AIRCOOLED MOTORS

48-50-1 Franklin Applies to All Bellanca 14-13, 14-13-2 and Universal (Stinson) 108, 108-1 Aircraft Equipped With Franklin Model 6A4-150-B3 and B31 Engines With Serial Numbers 11000 to 14000 Inclusive.

FIGURE 1

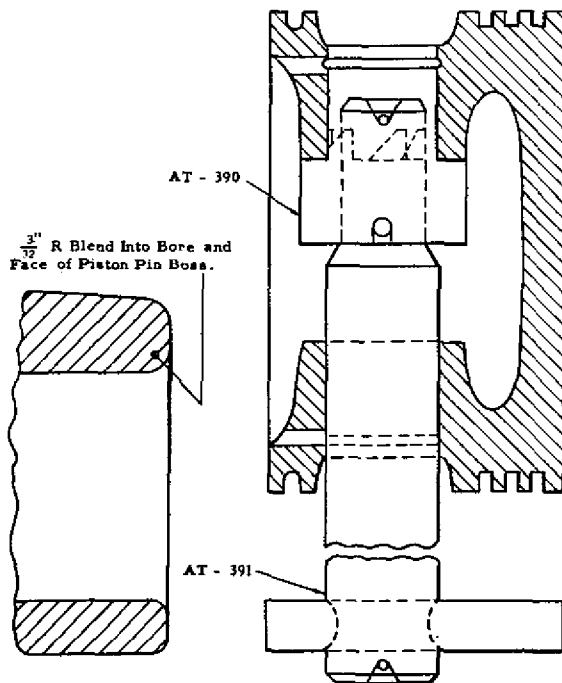
(b) Inspect pistons to ascertain if a $\frac{3}{32}$ -inch radius has been added at the inner ends of the ID of the piston pin bosses. Pistons which do not incorporate this radius should be modified as shown in Figure 1 in order to relieve stress concentrations. Pistons with cracks in this location which cannot be removed by the following modification should be discarded also.
